Access Compliance Report

Public Rights-of-Way

(Curb Ramps)

Intersection ID: 46753	Main Street: HAVASU_ST	Cross Street: CUMBERLAND_COVE_DR	Location: NW
ADA ID: E2545BF06682	Ramp Type: PerpDiag	Initial Pass/Fail: Fail	Overall Compliance: No
		Severity Score: 30

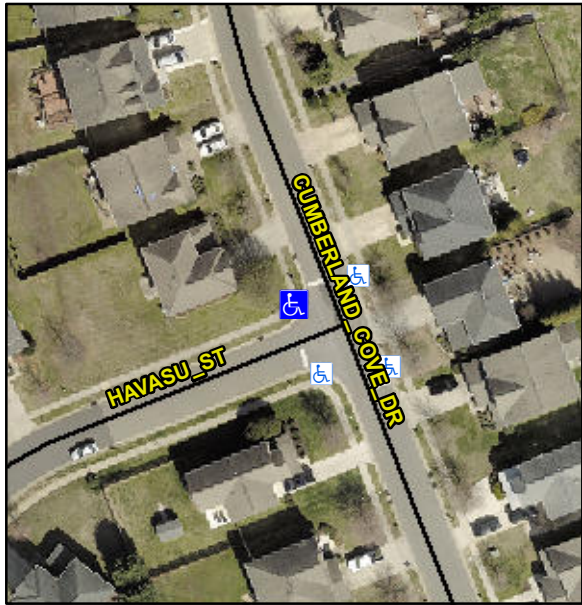
Codes/Mitigation Info/Possible Solution		Field Measurements/Component Compliance						
	Possible Solutions:		Compliance	Description	Data	Compliance	Description	Data
	Remove & Replace Curb Ramp With Two New Directional Ramps or Equivalent.		N/A	Ramp Length (in)	47.0	No	Ramp Slope (%)	11.5
			No	Ramp Width (in)	33.0	Yes	Ramp XSlope (%)	1.9
			N/A	Flare Type LT	N/A	N/A	Flare Type RT	N/A
			N/A	Flare Slope LT (%)	N/A	N/A	Flare Slope RT (%)	N/A
			N/A	Flare Traversable LT?	N/A	N/A	Flare Traversable RT?	N/A
	Surveyor Notes:		N/A	Landing Length (in)	N/A	N/A	DWS Provided?	N/A
			N/A	Landing Width (in)	N/A	N/A	DWS Contrast?	N/A
			N/A	Landing Slope (%)	N/A	N/A	DWS Length (in)	N/A
			N/A	Landing X Slope (%)	N/A	N/A	DWS Full Width?	N/A
N/A			Landing Curb? (Y/N)	N/A	N/A	DWS Offset (in)	N/A	
PROW/ADA: R304.5.1, R304.2.2		N/A	Shared Landing?	N/A				
		N/A	Gutter Ponding?	N/A	N/A	Gutter Slope (%)	N/A	
		N/A	Gutter Lip Ht (in)	N/A	N/A	Gutter X Slope (%)	N/A

N/A	Painted X Walk1?	No	N/A	Painted X Walk2?	No	
			X Walk 1 Direction	To SE		X Walk 2 Direction	To NE	
		N/A	X Walk 1 Width (in)	N/A	N/A	X Walk 2 Width (in)	N/A	
			X Walk 1 Slope (%)	1.2		X Walk 2 Slope (%)	1.9	
			X Walk 1 X Slope (%)	0.1		X Walk 2 X Slope (%)	0.4	
		N/A	Ramp inside XWalk1?	N/A	N/A	Ramp inside XWalk2?	N/A	
			Road Slope (%)	1.6	N/A	Clear Space?	N/A	
Total Cost:			Road X Slope (%)	0.2	N/A	Clear Space to XWalk (in)	N/A	
		N/A	Any Obstructions?	N/A	N/A	Storm Grate/Utility Hazard?	N/A	
			Obstruction Type			Storm Grate/Utility Type		
				N/A			N/A	
					Yes	Surface Condition? (G/P)	Good
